# TECHNICAL SERVICE BULLETIN

Bulletin Number: **V-04-03**

### SUBJECT: LOOSE FUEL LINE HOSE CLAMP AT FUEL RAIL

## INSPECTION / REPAIR PROCEDURE:

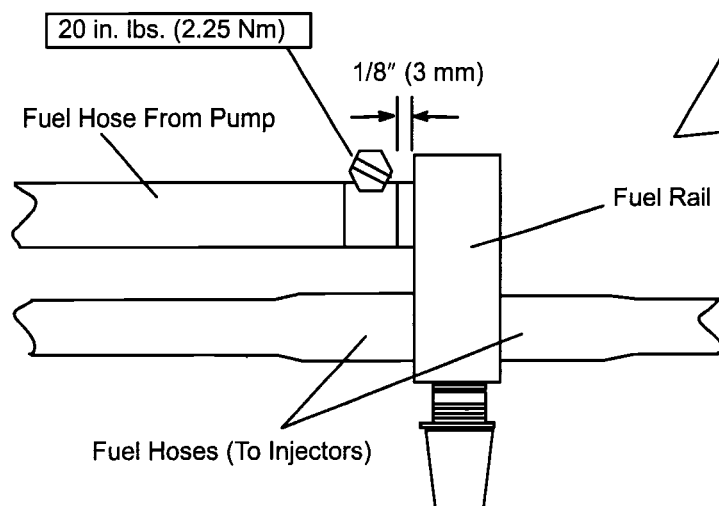
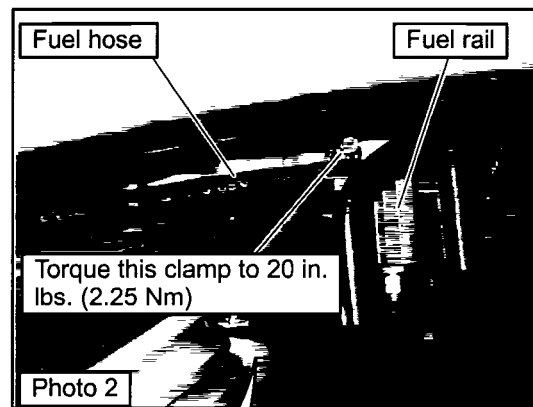
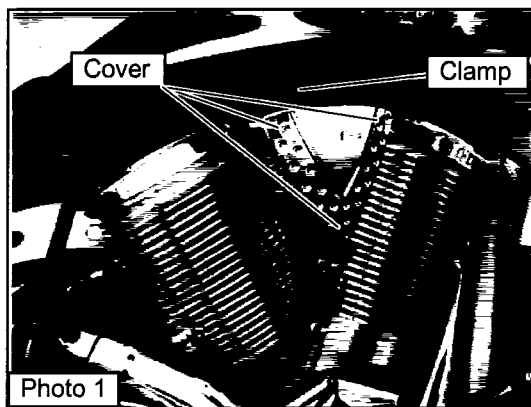
**PURPOSE:** The Victory Motorcycle Division of Polaris Industries Inc. has decided that the hose clamp that secures the high pressure fuel line to the fuel rail may be loose, allowing fuel to leak from the hose on some 2005 Victory motorcycles. Fuel leakage around the fitting creates the potential for a fire. **DO NOT SELL, DELIVER, OR OPERATE AN AFFECTED UNIT UNTIL THE REPAIR PROCEDURE ON PAGE 4 HAS BEEN COMPLETED!**

1. Remove the triangular chrome fuel rail cover located on the right side of the motorcycle by pulling outward evenly at all corners. (**Photo 1**)
2. Locate the fuel hose clamp on the fuel rail as shown in **Photo 2**.
3. Inspect the hose on the fuel rail fitting. Be sure the fuel hose is pushed completely onto the fitting, and the hose clamp is positioned 1/8 inch (3 mm) from the end of the hose.
4. If necessary, loosen the clamp as required and re-position it with the screw head accessible and the clamp 1/8 inch (3mm) from the end of the hose.
5. Torque the clamp to 20 in. lbs. (2.25 Nm)
6. Start the engine and inspect for leaks.
7. Install fuel rail cover.
